DEVIATION REQUEST AND DECISION FORM

PROJECT INFORMATION – NEW LOG ROAD DEVIATION REQUEST

Project Name : Ellicott Town Center Filing No. 1

DEVELOPED DRAINAGE PLAN

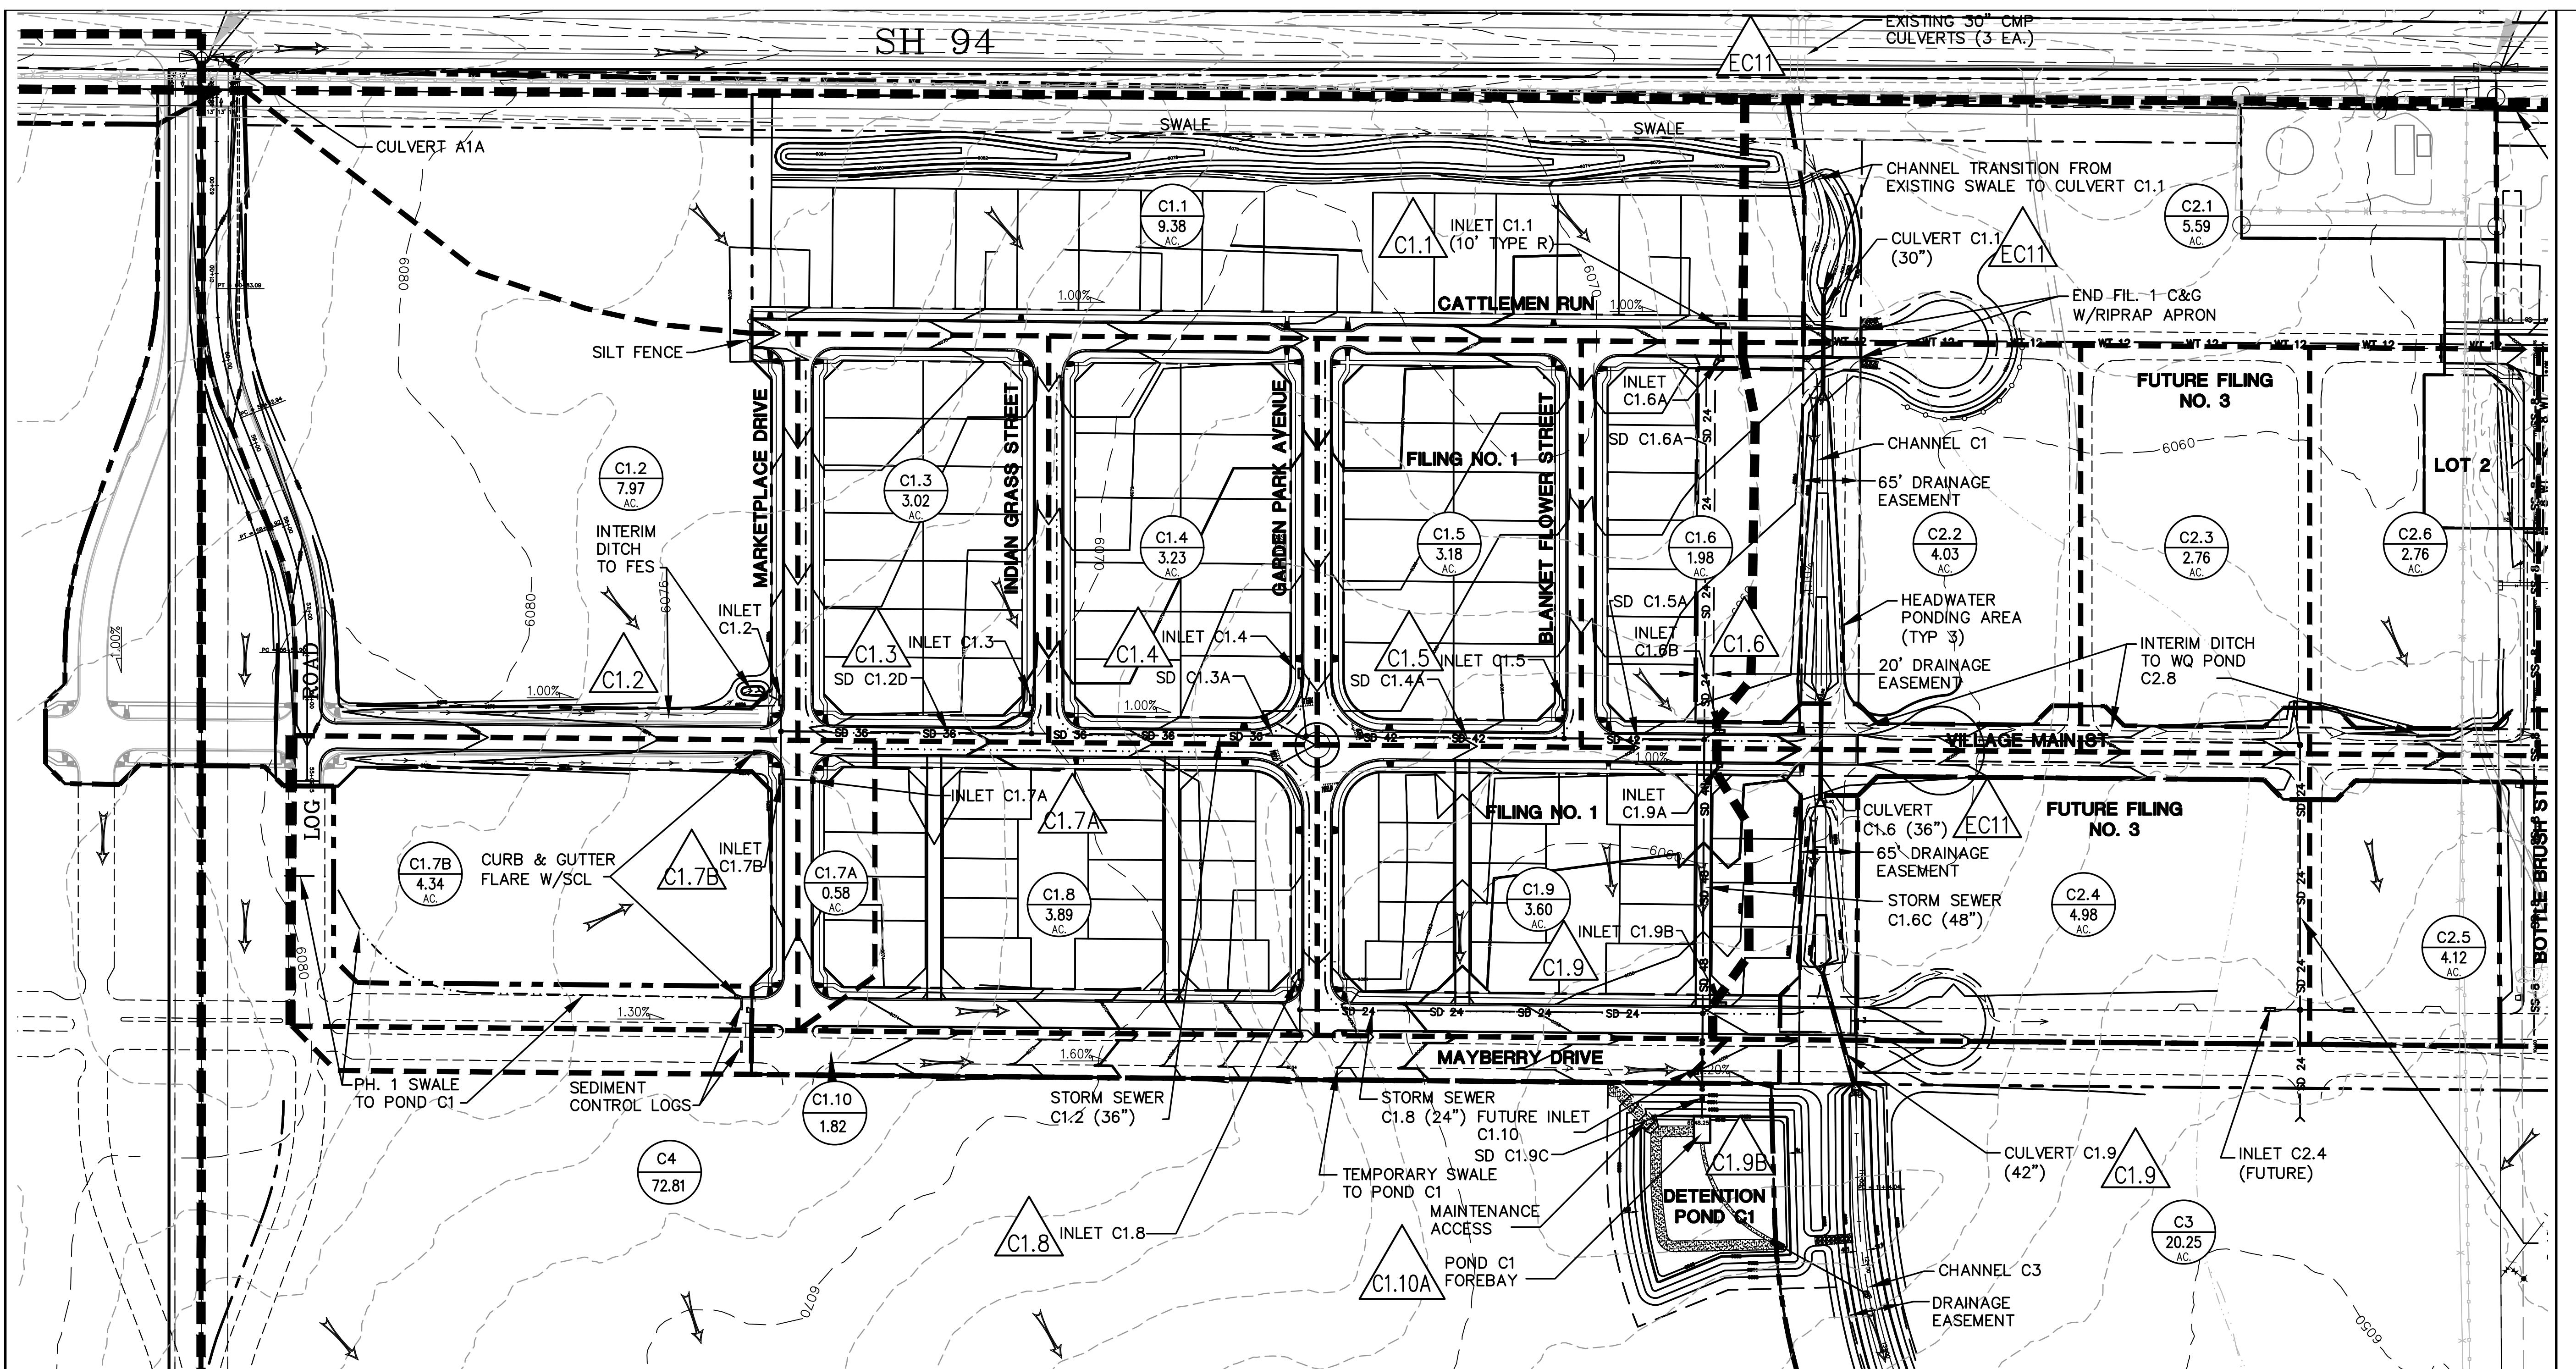
The areas excluded from water quality treatment are associated with the limited residential lot area between the east edge of Filing No. 1 and Channel C1. In this area, water quality treatment is not practical based on topographic constraints. However, this area sheet flows to Channel C1, which is a grass-lined drainage channel providing water quality mitigation.

The limited impervious areas excluded from water quality treatment consist of the residential lots between the east edge of Filing No. 1 and Channel C1. In this area, water quality treatment is not practical based on topographic constraints. However, the excluded areas will sheet flow to Channel C1, which is a grass-lined drainage channel providing water quality mitigation. Also, substantial stormwater detention and water quality facilities are being provided to mitigate the overall drainage impacts from the development.

1. DEVIATION REQUEST PROCESSED TO ALLOW DEVELOPED FLOW FROM WEST SIDE OF BASIN C2.1 (LOT 15) AND BASIN C2.4 (LOTS 95–98) TO SHEET FLOW INTO CHANNEL C1.
 2. FUTURE FILING NO. 3 DEVELOPMENT SHALL PROVIDE AREA DRAINS TO COLLECT FLOW FROM THE WEST SIDE OF BASIN C2.2 (LOTS 16–22) AND CONVEY THIS DEVELOPED FLOW TO INLET C1.6B
